Staff Report

To: Salt Lake City Planning Commission
From: Eric Daems, Senior Planner
eric.daems@slcgov.com, 801-535-7236
Date: May 22, 2024
Re: PLNPCM2023-00890- Carrigan View Phase 2- Planned Development
PLNSUB2024-00219- Carrigan View Phase 2- Preliminary Subdivision

Planned Development & Preliminary Subdivision

SLOPE MAP

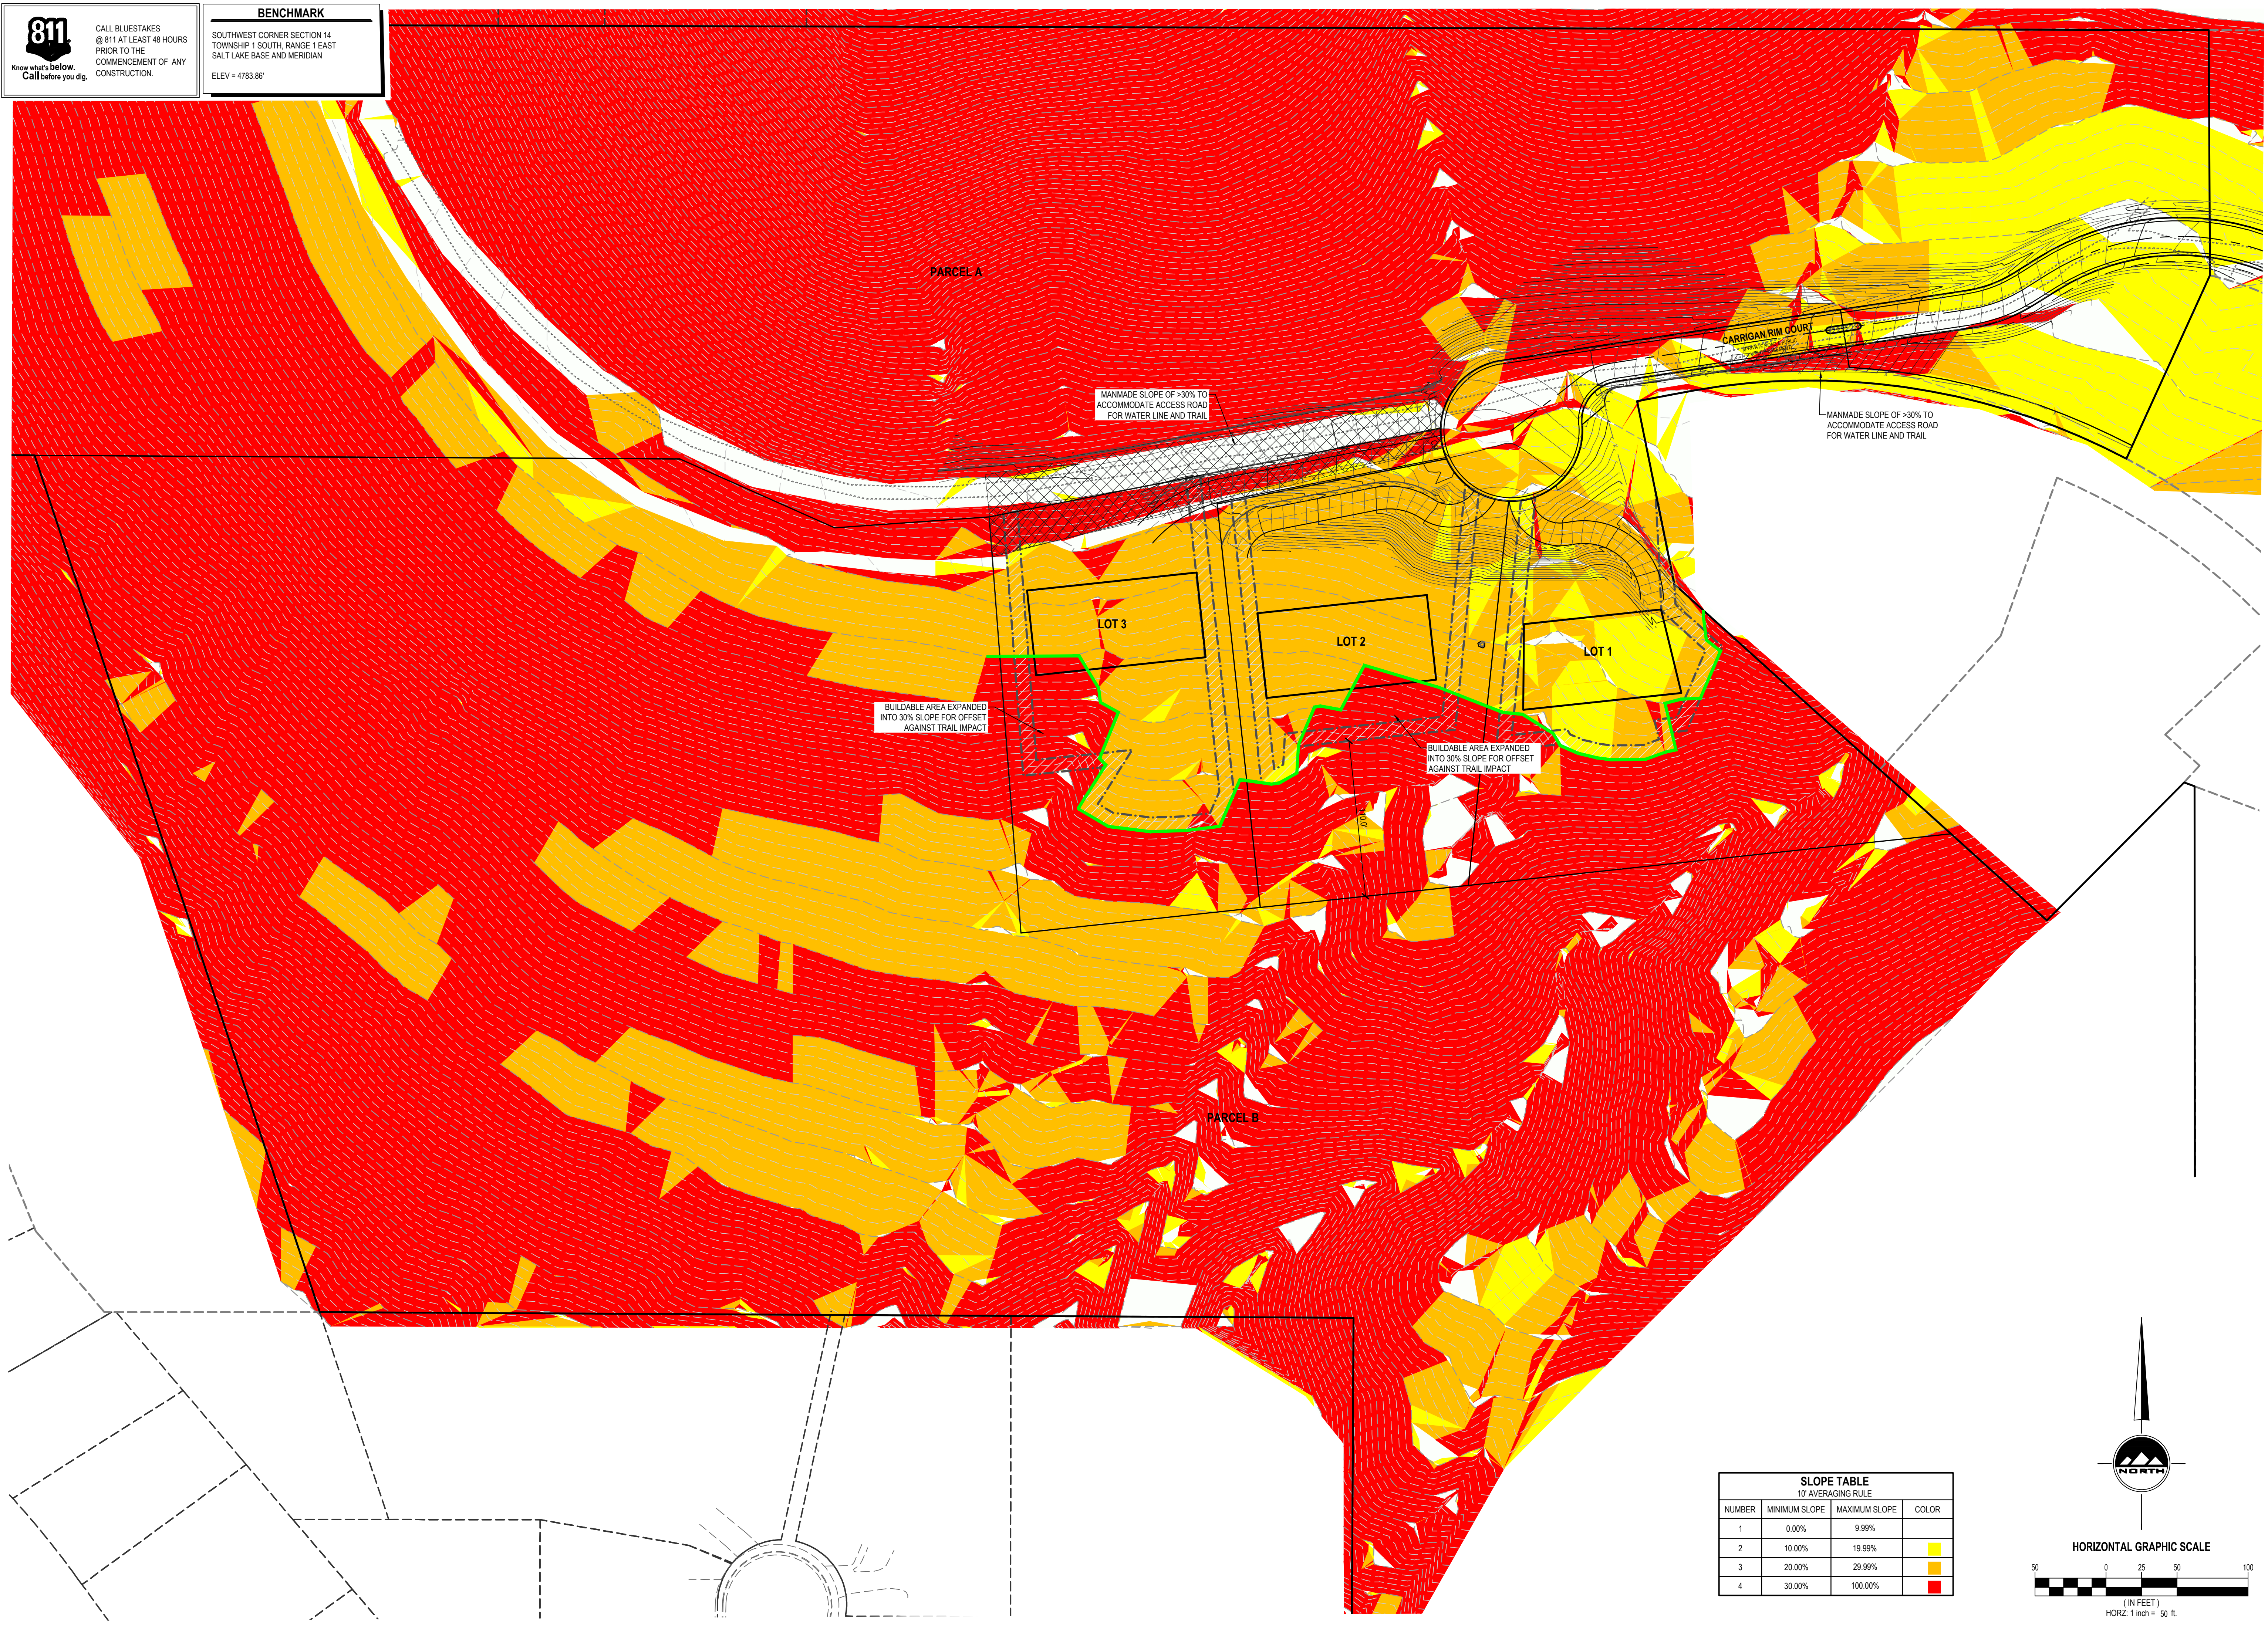
- Three residential lots do not front on a public street- rather, a private street is proposed.
- Lot 3 is 50' wide at the front yard setback where 100' would be required.
- Lots 2 and 3 include minor portions of their buildable area which include slopes that exceed 30%.
- The private road (Carrigan Rim Court) would include construction across manmade slopes that exceed 30%.

1 ROAD CROSS SECTION
CARRIGAN RIM COURT
SCALE: NONE

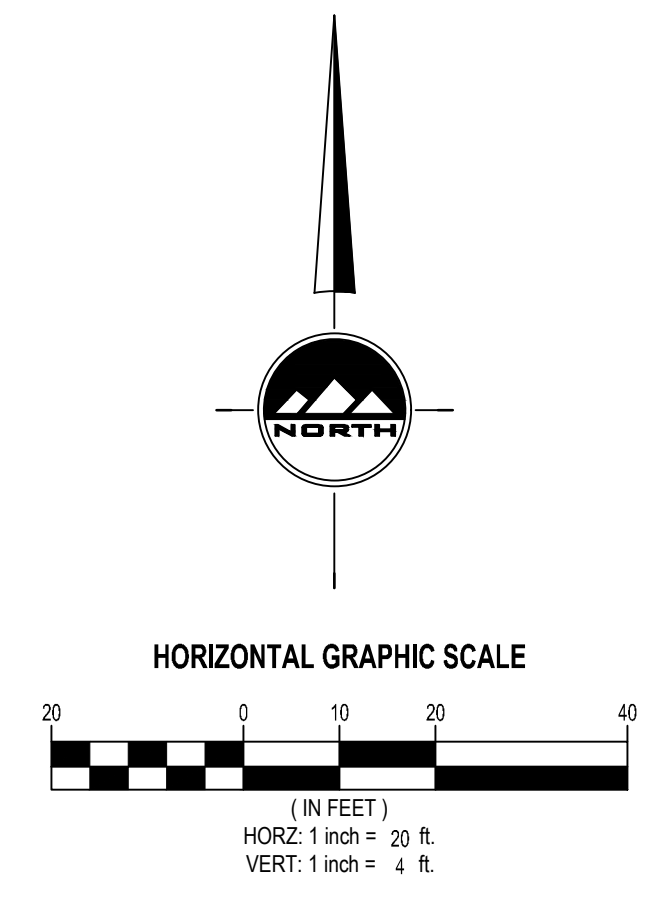
- Trail cannot run through drainage channel as it would cause substantial rutting and other problems. With the private road removing the existing trail, this needs to be engineered in an acceptable manner for an at least 6' trail to function. The premise of the Planned Development is to create a public benefit, so this element is critical to solve. As drawn, it is more of a private benefit to handle the drainage for the private development. Trail surface needs to have a convex crown.

2. Minimum 6’ wide trail to be provided north of Carrigan Rim Court and to be acceptably engineered so as to not be impacted by water run-off.
3. A geo technical evaluation related to slope and waterway protection and mitigation be performed prior to building permits being issued.
4. Any areas disturbed during construction be revegetated with native plants.
